**RIVERDALE CITY PLANNING COMMISSION AGENDA
CIVIC CENTER - 4600 S. WEBER RIVER DR.
TUESDAY – AUGUST 10, 2021**

**RIVERDALE CITY
PLANNING COMMISSION AGENDA
August 10, 2021**

SUBJECT: Consideration to forward a recommendation to the City Council of a proposed Site Plan Amendment for Walmart Supercenter, property located approximately 4848 South 900 West, Riverdale Utah 84405, as requested by Walmart and Galloway & Company, Inc.

Amended Site Plan Review – Walmart, 4848 South 900 West

SHEET: CS1

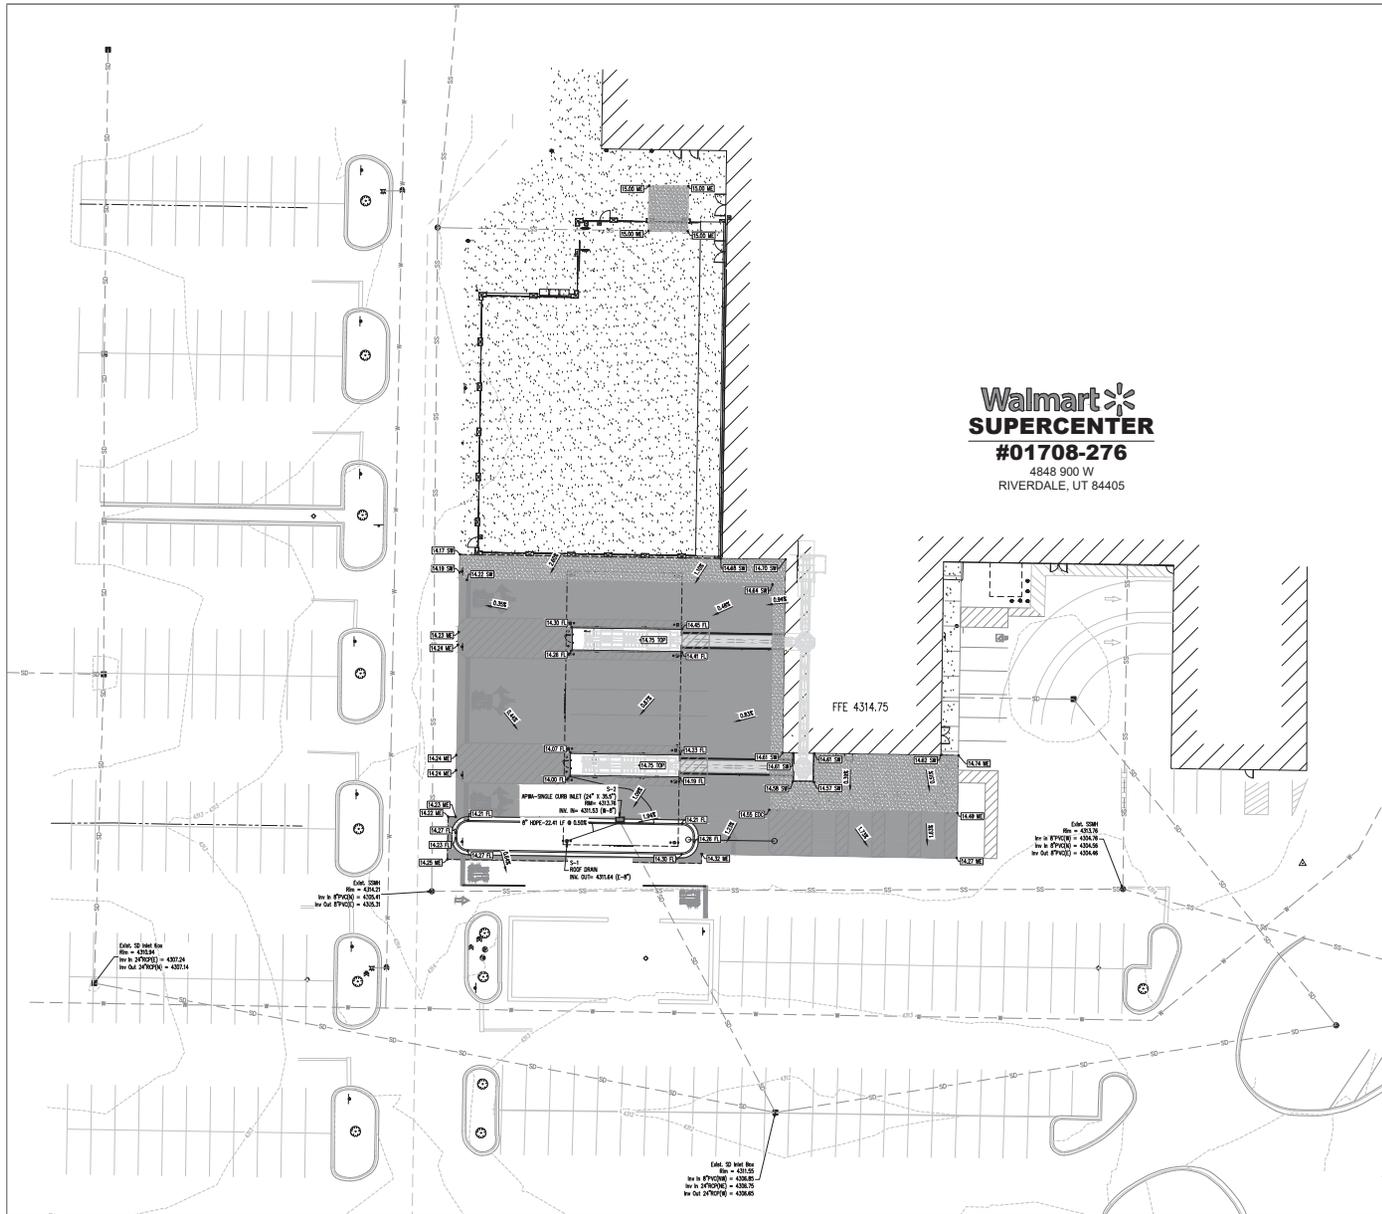
Calculations for retention system	No updated calculations provided; defer to City Engineer
Method of storm water clean-up	Existing method noted on CS1; erosion control plan provided; defer to City Engineer
<u>New and Existing Sanitary Sewers</u>	
Manholes	Existing shown on multiple sheets; new shown on multiple sheets;
Invert elevations	This is not shown, defer to City Engineer
Length, size, type, and slope of mains and laterals	Shown on CS1, no detail provided, defer to City Engineer
<u>New and Existing Water Lines</u>	
Length, size, type, and slope of mains and laterals	Shown on CS1, no detail provided, defer to City Engineer
Location, size, and type of water meters, valves, and fire hydrants	Existing water location shown; water meter size, and type not identified, where applicable; location of existing valves shown; existing fire hydrants for site shown; no new hydrants planned for this site plan
